The attention of bidders submitting proposals for the subject project noted above is called to the following Addendum to the Contract Forms and Specifications.

This Addendum consists of the following information:

TWIN TOWERS
MIDDLE SCHOOL

ENLARGED CITY SCHOOL
DISTRICT OF MIDDLETOWN

1 GROUND FLOOR ABATEMENT PLAN
1/16" = 1'-0"

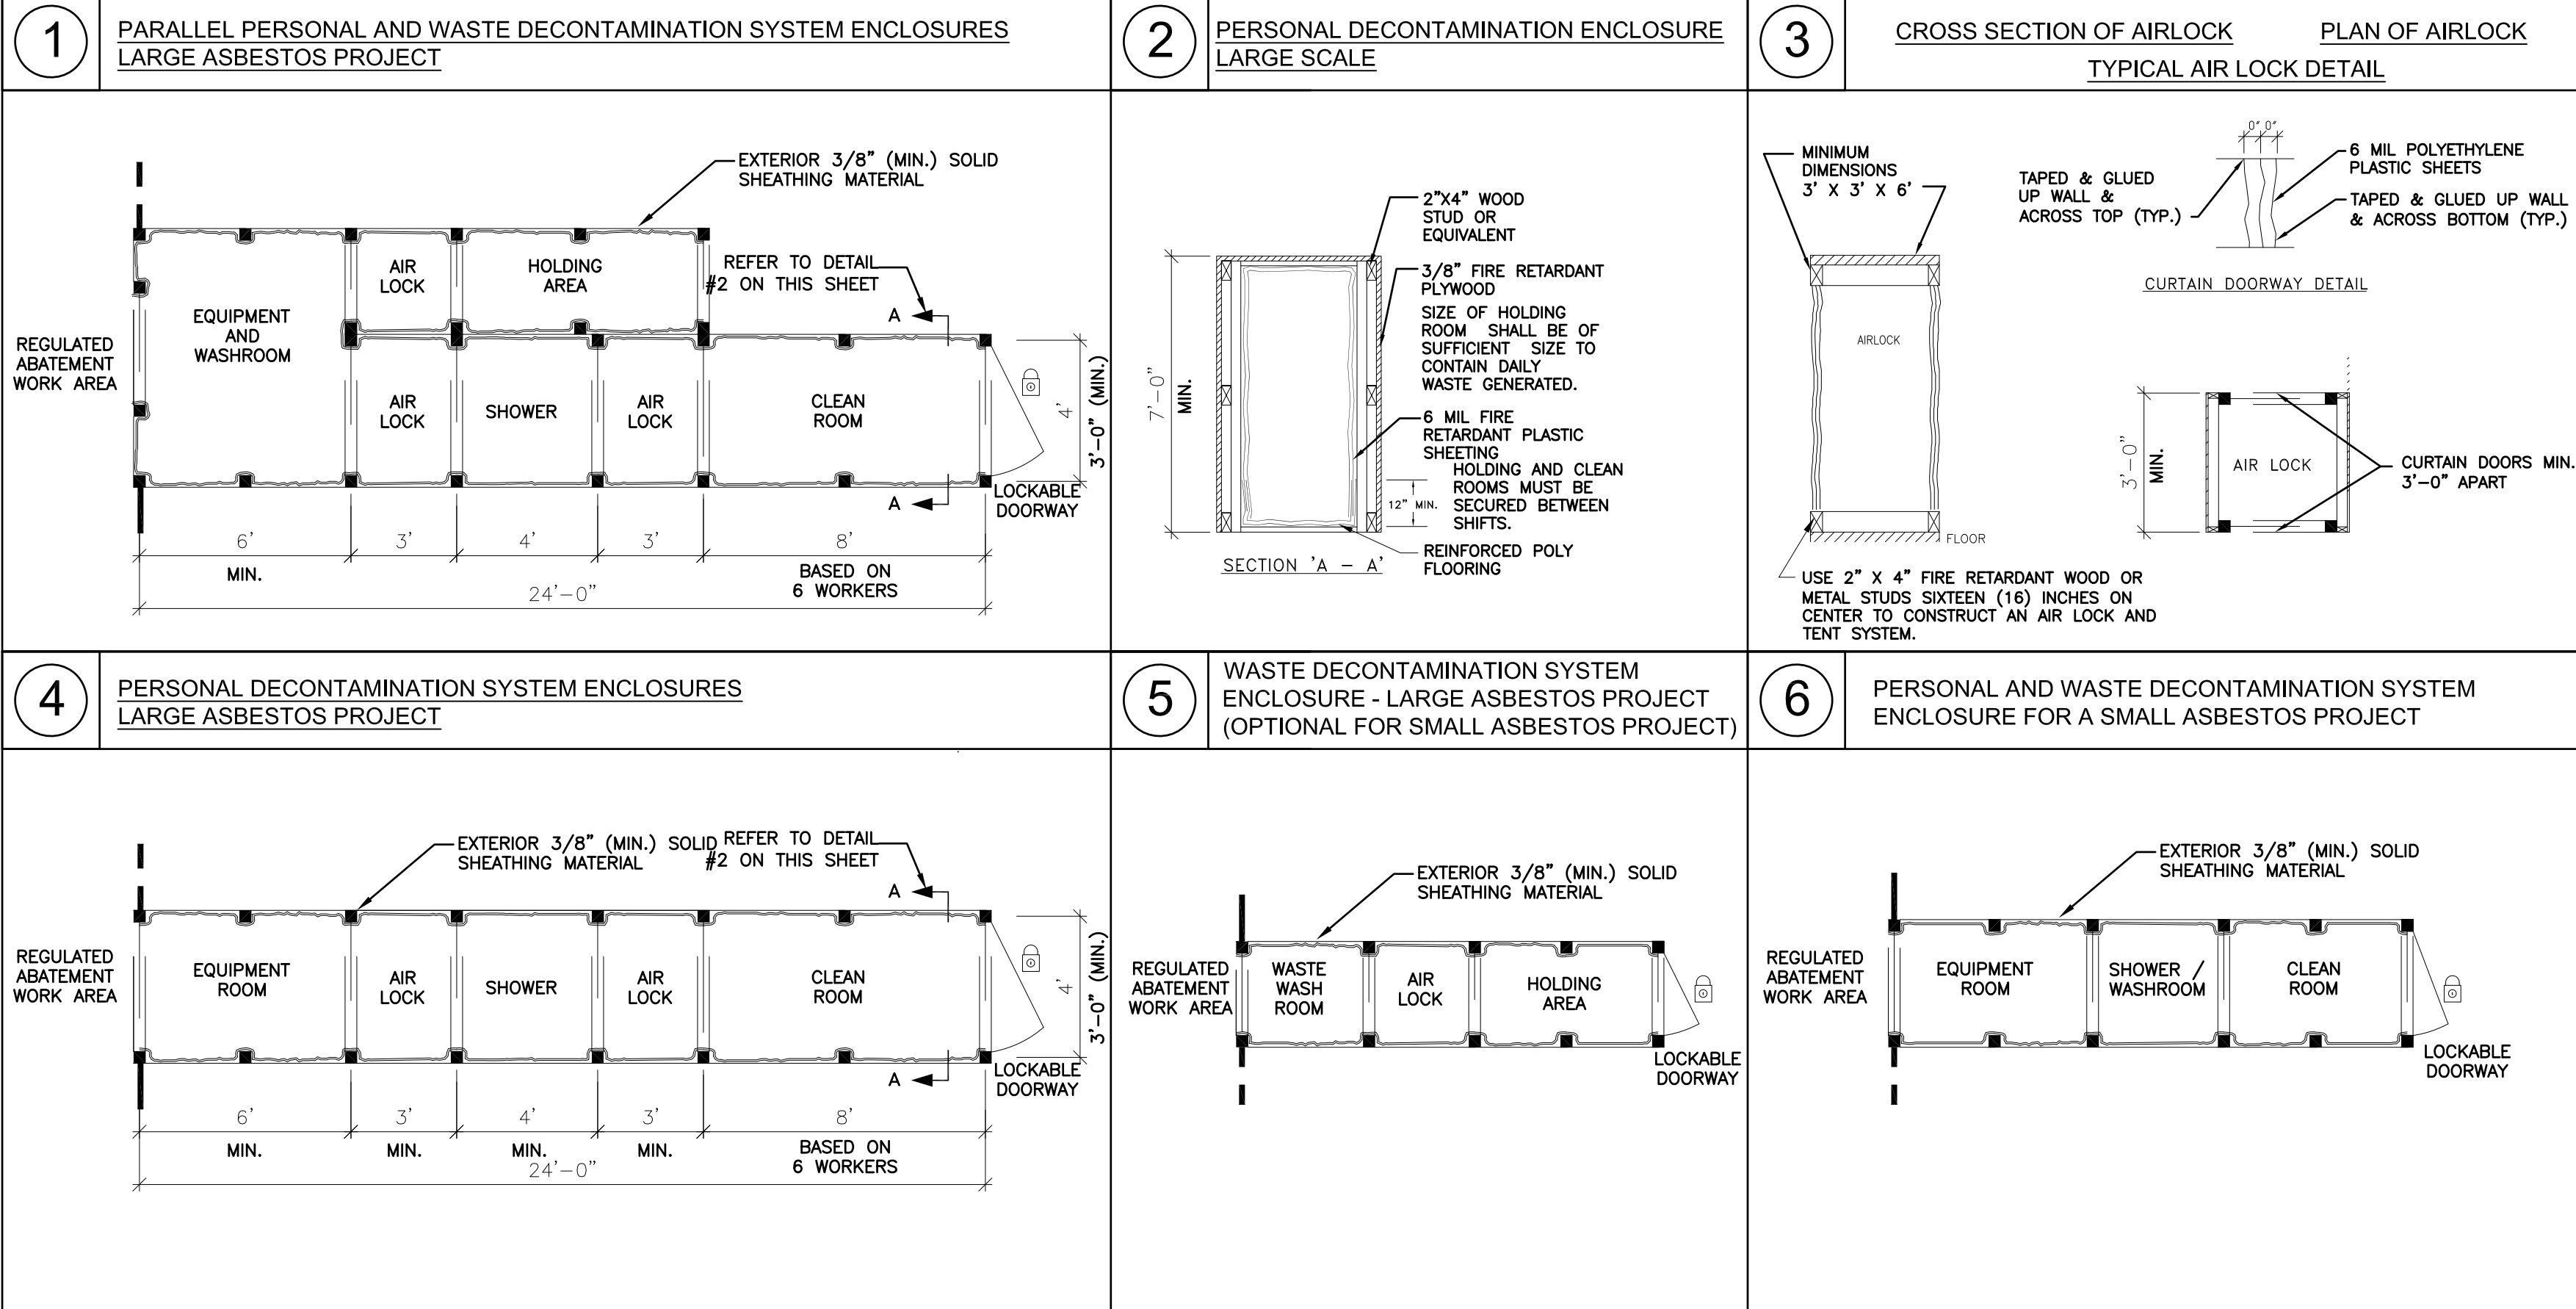
- 1) Drawings AA101, AA102 & AA103 Abatement Plans
 - a. REMOVE keynote AA5 from windows along the East façade of Area A. See attached drawings
 - b. ADD keynote AA5 at (2) locations within courtyard.
 - c. REVISE quantities within keynotes.
- 2) Drawing A805 – Detail A3 (Change) Note (within box) to Read – Provide 1hr Intumescent Paint on All Exposed Steel within Stair A & B.
- 3) Drawing A903 – Door Schedule
 - a. CHANGE doors 101 & 113 to note that existing frame & glazing assembly to remain (historic). Doors shall be replaced as scheduled.
 - b. CHANGE door C008a to be a double door (2 leaves) with hardware set 10.2. This change reduces infill required of exterior masonry wall after temporary egress doors shown on LP002 are removed.

| ASBESTOS ABATEMENT KEYNOTES | | QTY |
|-----------------------------|--|--|
| AA5 | REMOVE AND DISPOSE OF WINDOW AND ALL CAULKING / SEALANTS AT EXTERIOR OF WINDOWS. CAULKING / SEALANTS SHALL BE REMOVED FROM ALL METAL TRIM, WOOD TRIM, WINDOW FRAMES, BUILDING SUBSTRATES AND THE LIKE. WINDOWS SHALL BE CLEANED / DECONTAMINATED OF ALL ASBESTOS CONTAINING MATERIALS AND MAY BE DISPOSED OF AS GENERAL CONSTRUCTION DEBRIS. | 350 LIN. FT. / 20 SQ. FT. OF CAULKING / SEALANTS |

1 PLUMBING - FIRST FLOOR PLAN - AREA A

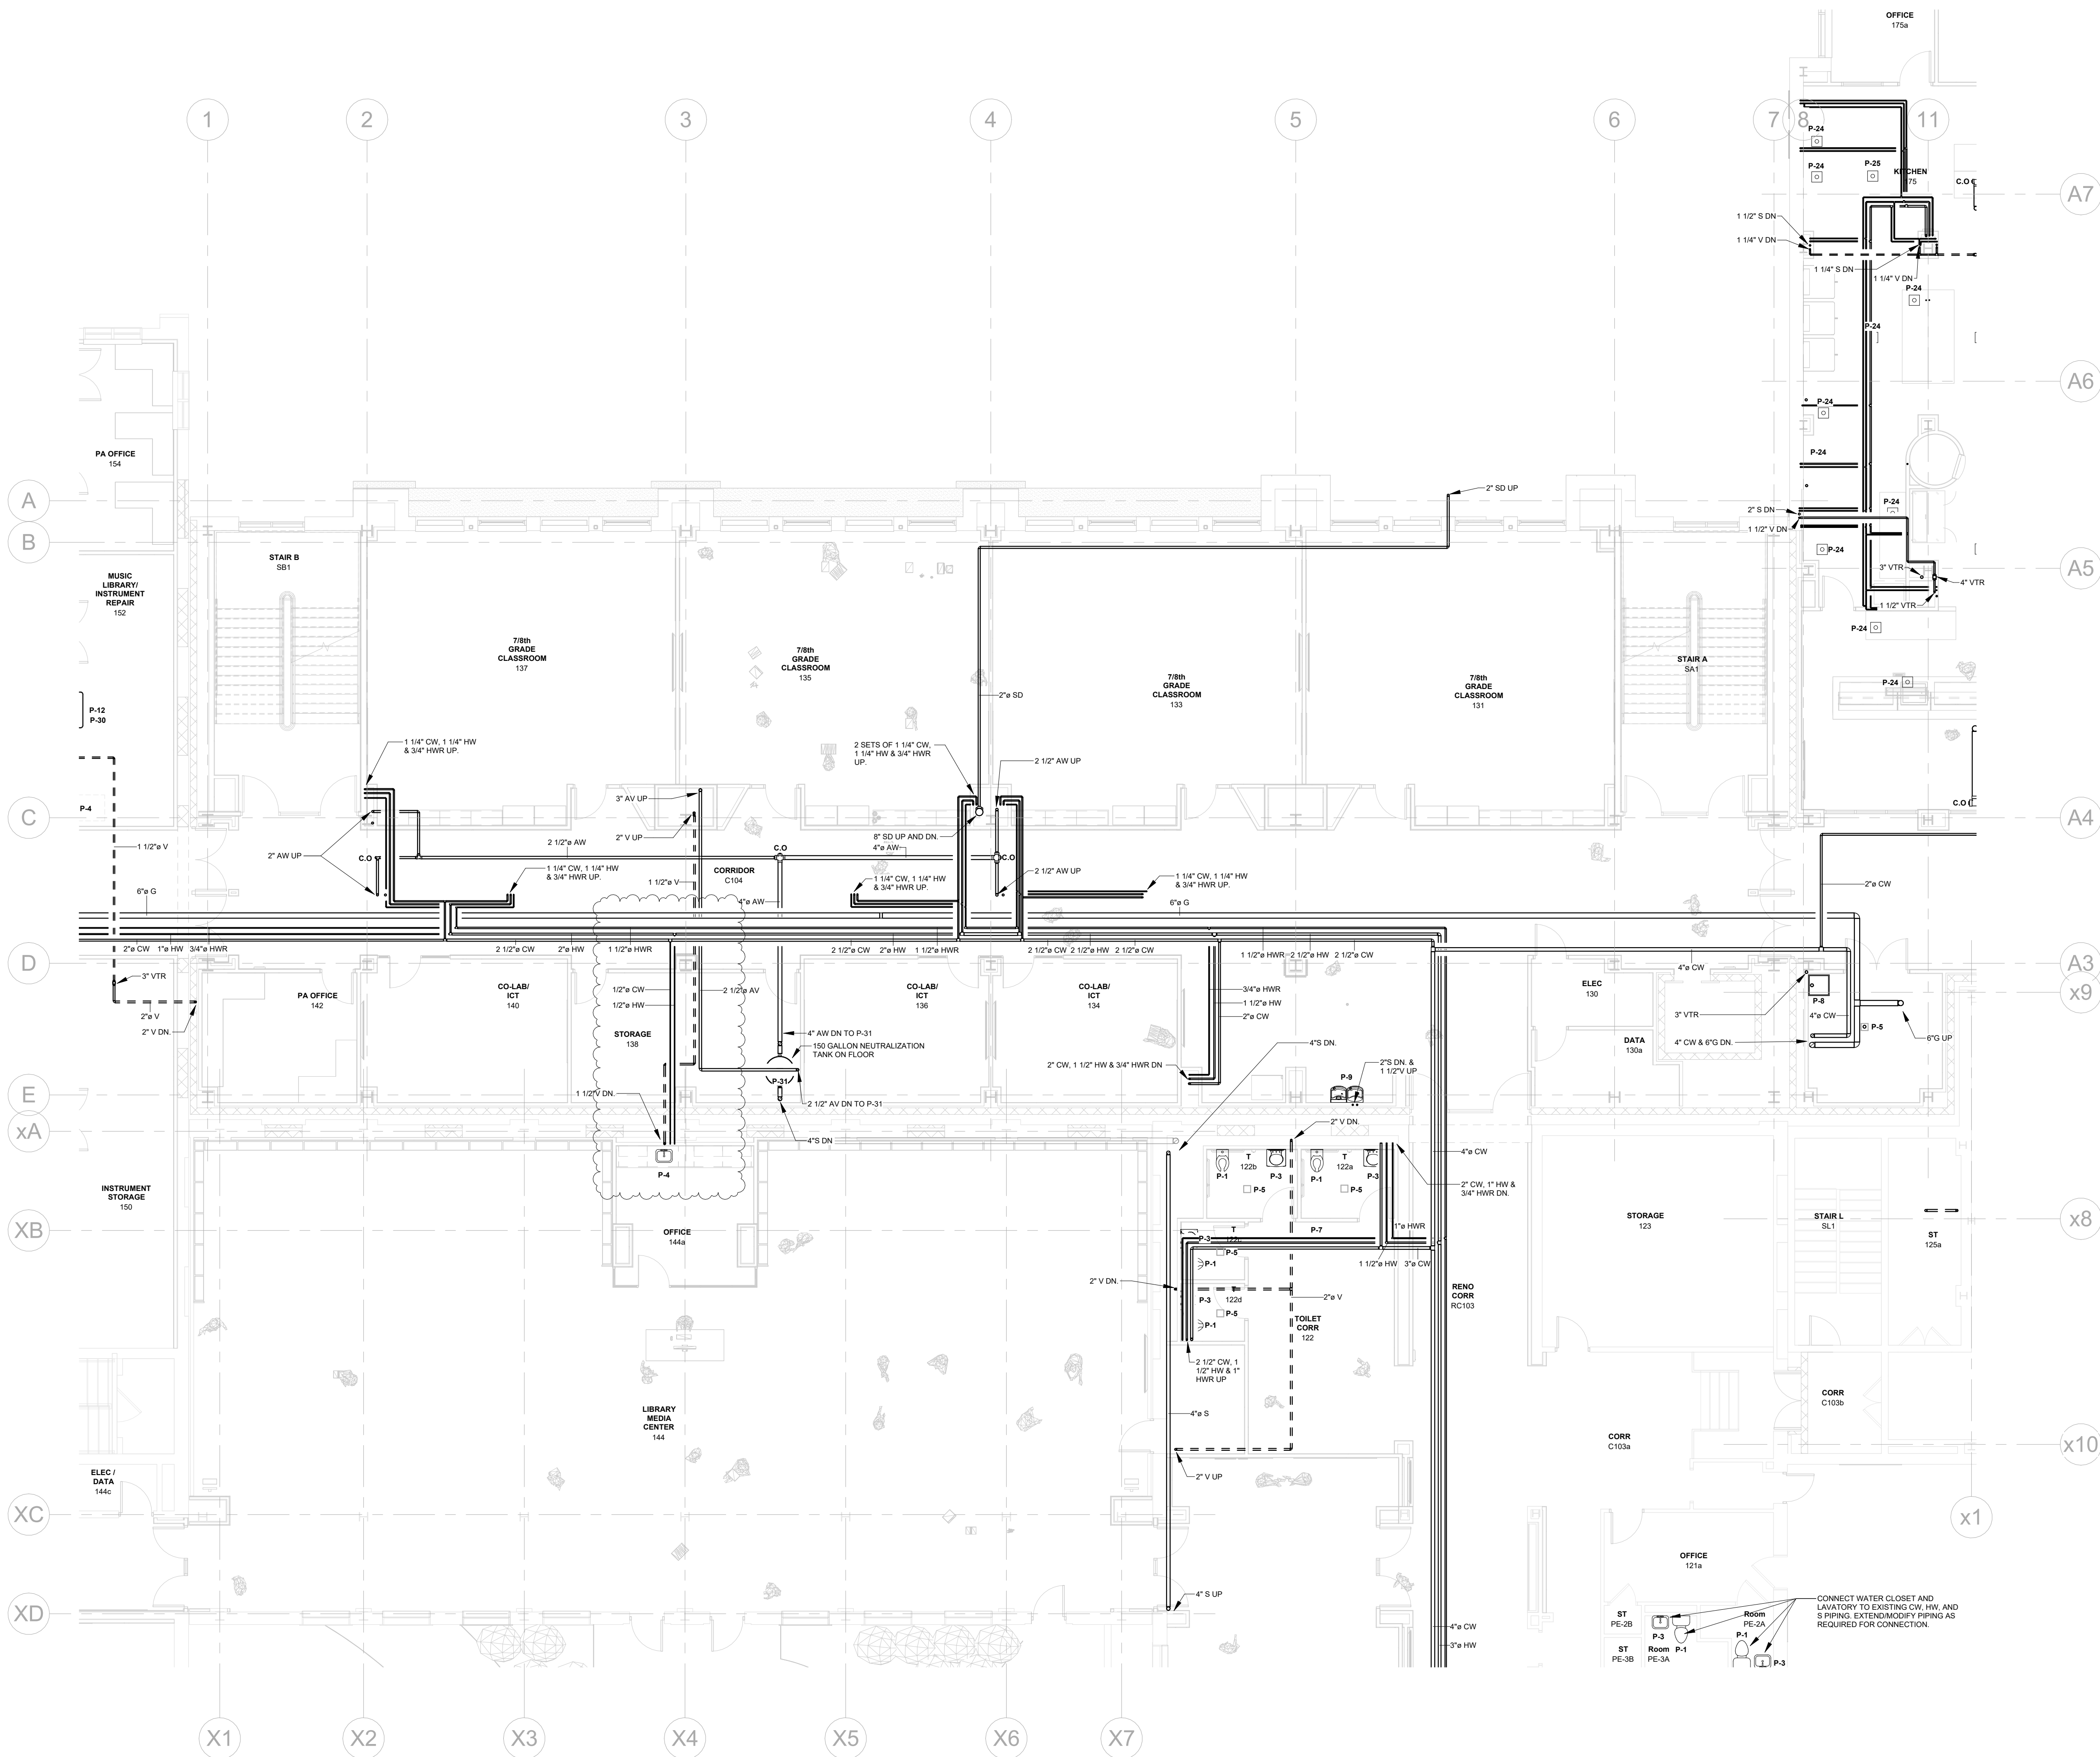
- 1) Drawing P200.A – REVISE drawing to show correct toilet fixture tag. Refer to revised drawing included with addendum.
- 2) Drawing P201.A – REVISE drawing to show additional cold and hot water vent piping. Refer to revised drawing included with addendum.
- 3) Drawing P201.C – REVISE drawing to show correct toilet fixture tag. Refer to revised drawing included with addendum.

1 PLUMBING - FIRST FLOOR PLAN - AREA N
1/8" = 1'-0"

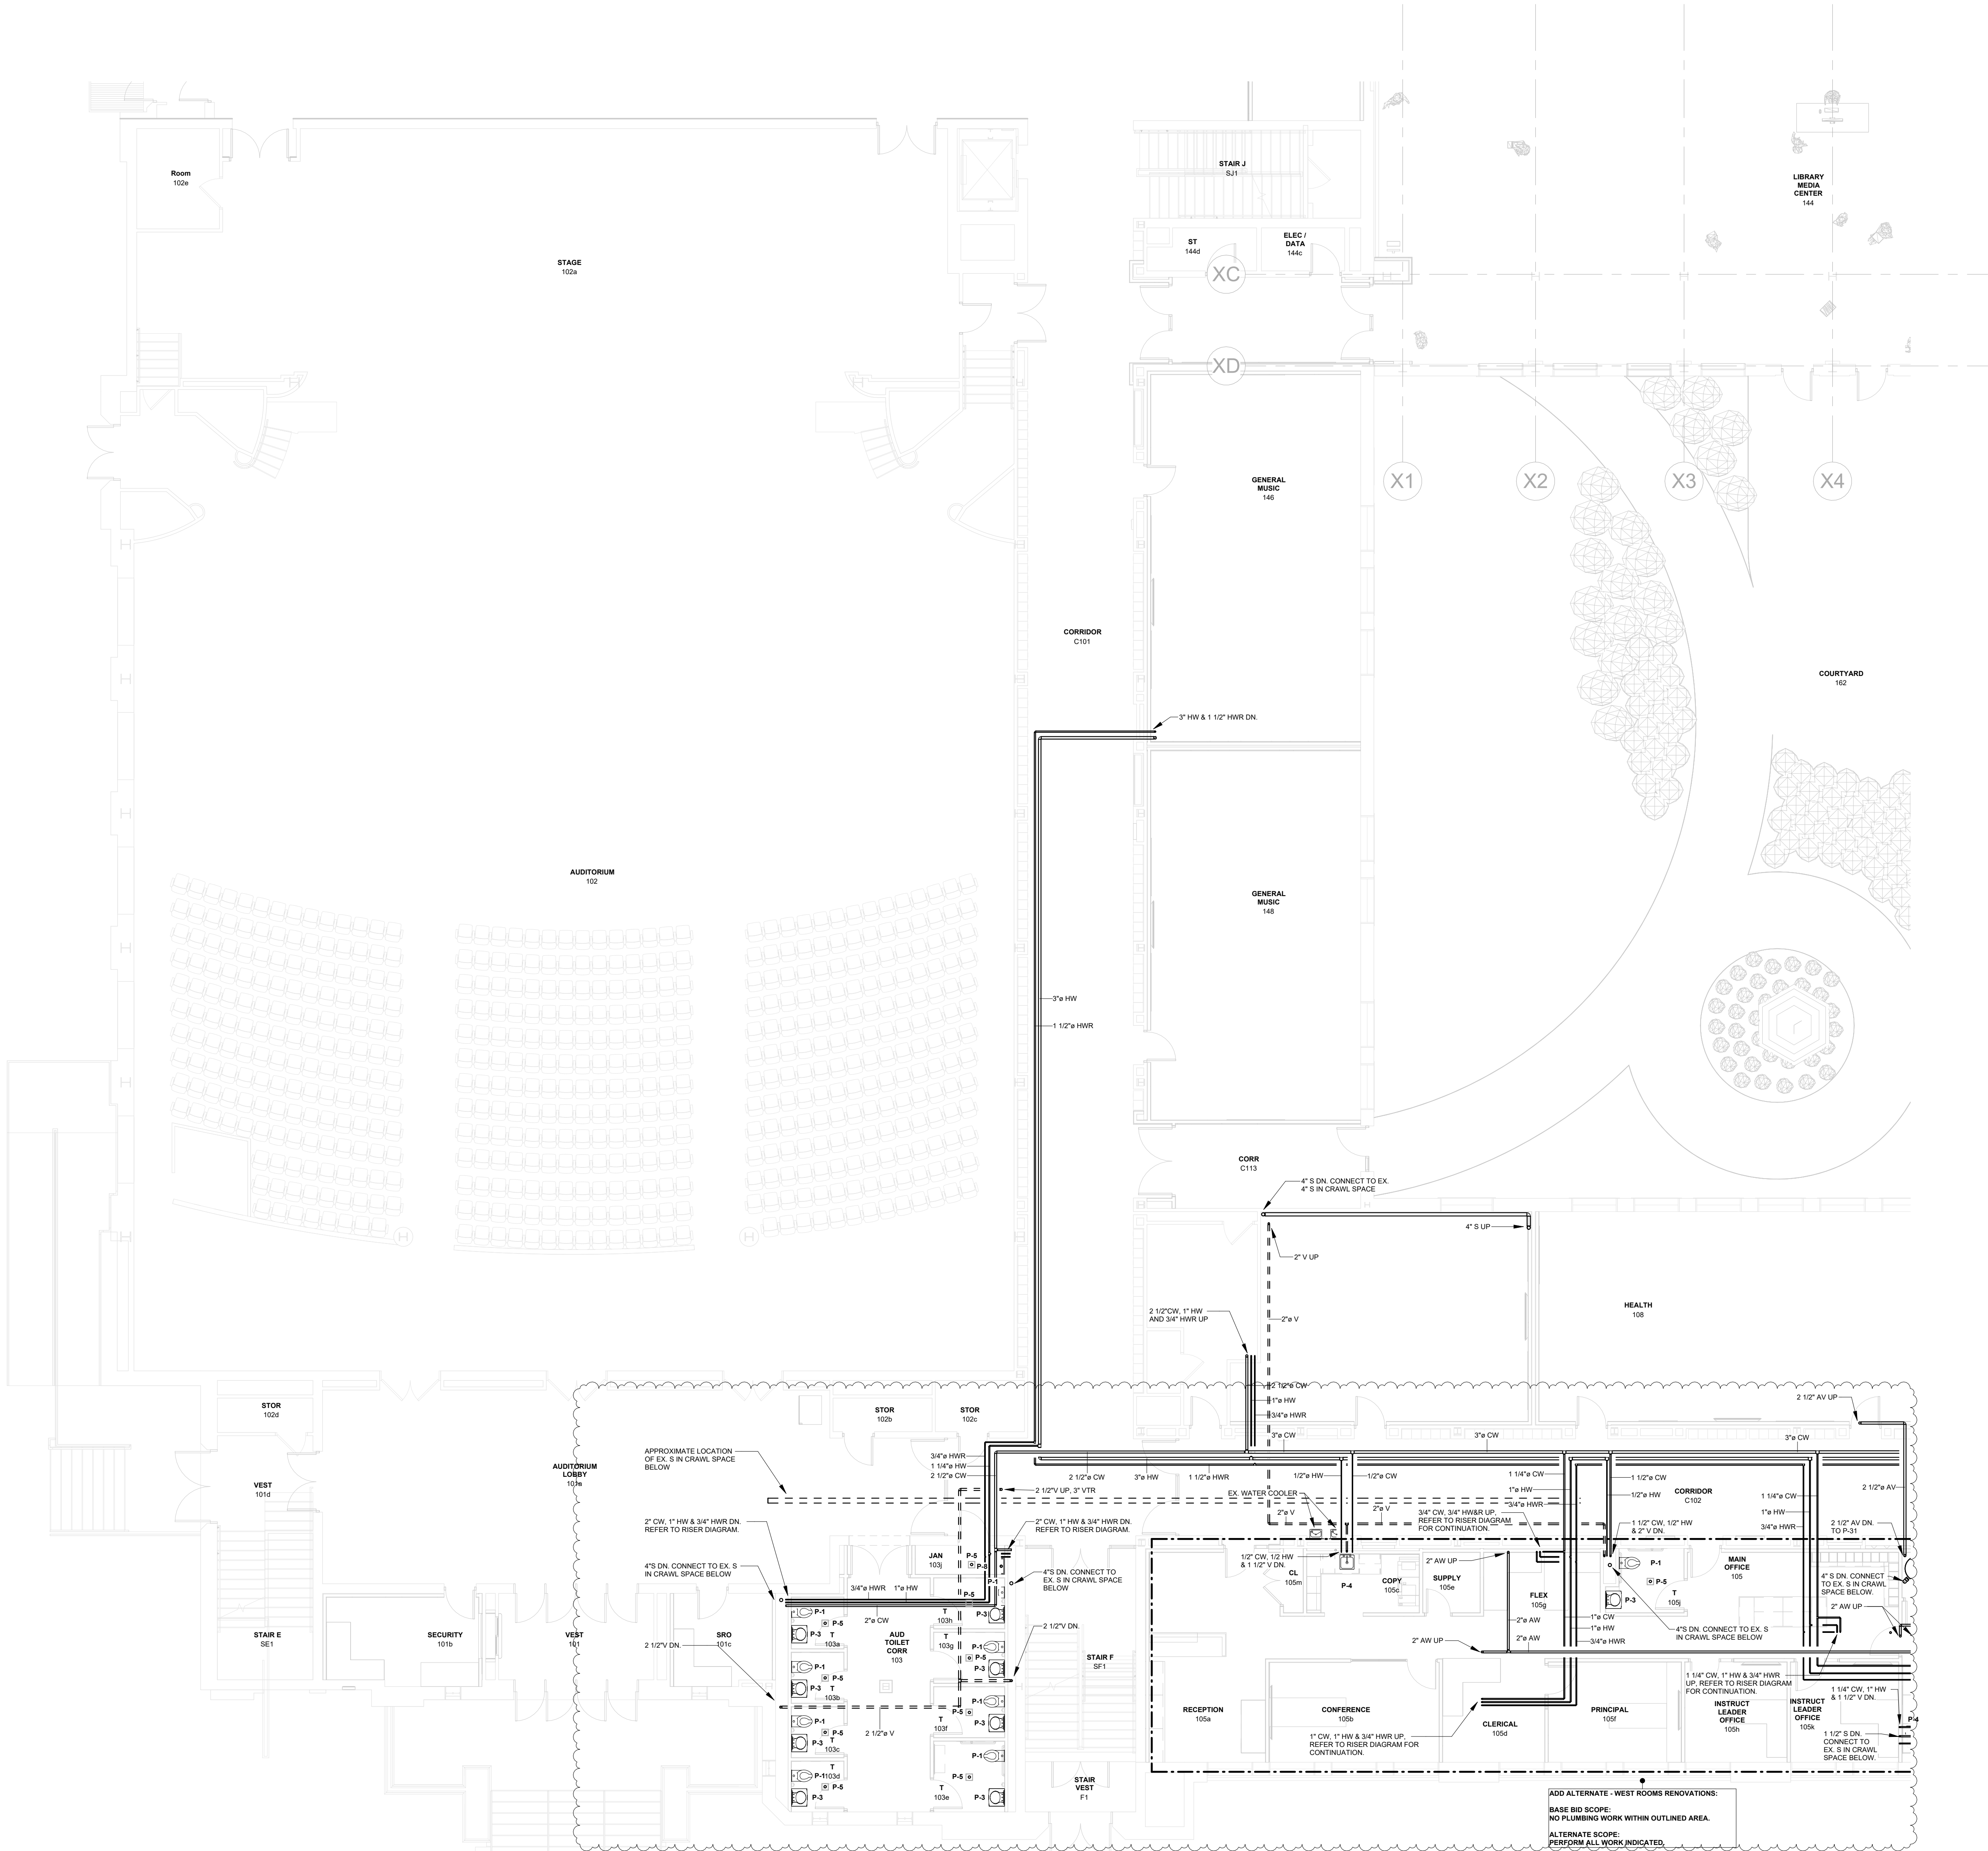
- 4) Drawing P201.N – REVISE drawing to clarify pipe drop locations. Refer to revised drawing included with addendum.
- 5) Drawing P201.S – REVISE drawing to clarify pipe drop locations. Refer to revised drawing included with addendum.
- 6) Drawing P202.NS – REVISE drawing to clarify pipe drop locations. Refer to revised drawing included with addendum.
- 7) Drawing P203.NS – REVISE drawing to clarify pipe drop locations. Refer to revised drawing included with addendum.
- 8) Drawing P701 – ADD floor mounted water closet. Refer to revised drawing included with addendum.
